CONTINUATION SHEET

PART 3- PROJECT PROGRAM

The purpose of this project is to construct a new multi-story Marine Corps Bachelor Enlisted Quarters (BEQ) at Naval Weapons Station (NWS) Yorktown in Yorktown, Virginia. The project is part of a multi-phase consolidation of the Marine Corps Security Force Regiment (MCSFR). The new facility will provide berthing facilities for Marines of MCSFR Headquarters Company currently located at Camp Allen, Naval Station Norfolk, and NSA Norfolk. In addition, the facility will fill deficit BEQ housing for MCSFR "B" FAST Company at NWS Yorktown. The consolidation plan will locate the new BEQ south of the MCSFR Parade Ground and east of P-985 BEQ. The multi-story BEQ facility north (parade field side) elevation shall be a maximum height of three stories.

Diagram for Temporary Containment
of Petroleum Contaminated Soil

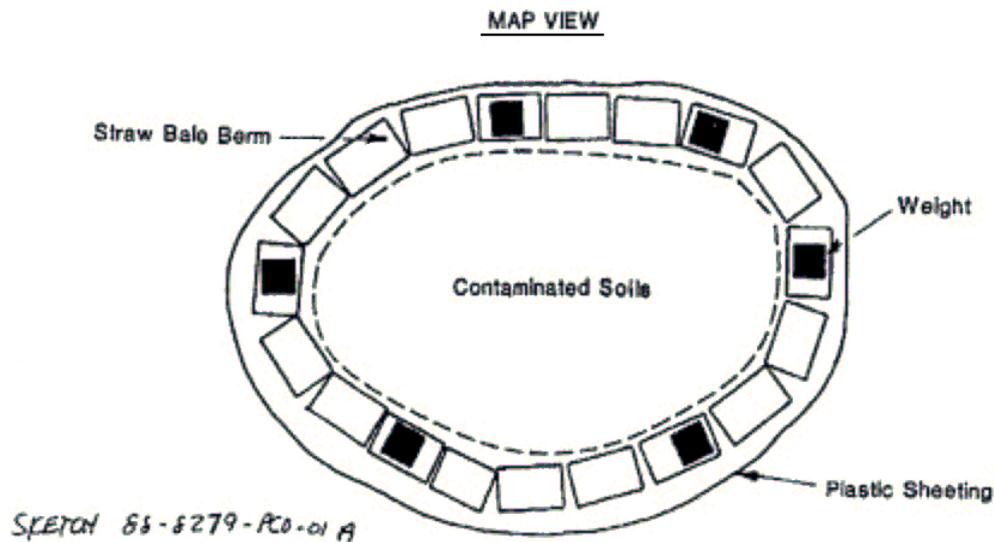
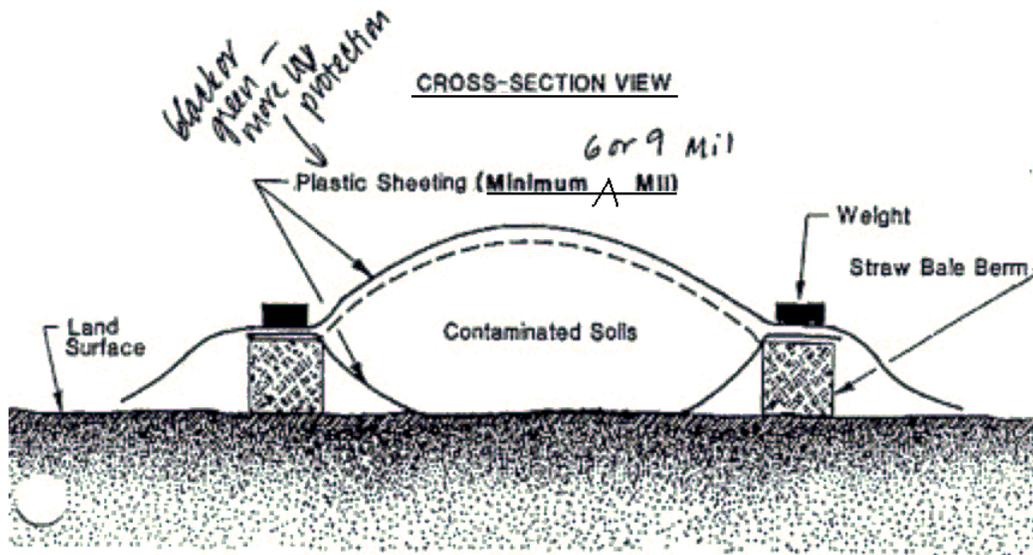
If soil saturated with petroleum (e.g. when the soil is squeezed, oil/gas drips out) is encountered in the planned excavations, then the Contractor shall immediately stop excavation operations in that area and contact NAVFAC MIDLANT EV (POC: Carol Peterson, 757-341-0453 office or 757-285-2560 cell). MIDLANT EV personnel or their agents will monitor and direct the removal of soil saturated with petroleum. Petroleum contaminated soil will be disposed of through a treatment service such as Clearfield (formerly known as Soilex) [757-549-8448 <http://www.clearfieldmmg.com/>]. Soil testing for the following constituents will be required before treatment facilities will accept the soil: TPH, BTEX, EPTOX, Total Organic Halogen (TOX). Soils that are less than 50 ppm TPH (total petroleum hydrocarbons) can be used elsewhere within the confines of the project. Soils >50 ppm will be stored in a manner to prevent rain from reaching the soil and preventing any runoff into the surrounding soil or pavement (e.g. store the soil on top of plastic sheeting and covered with plastic sheeting or in lined, covered dumpsters). The following figure provides a sample configuration.
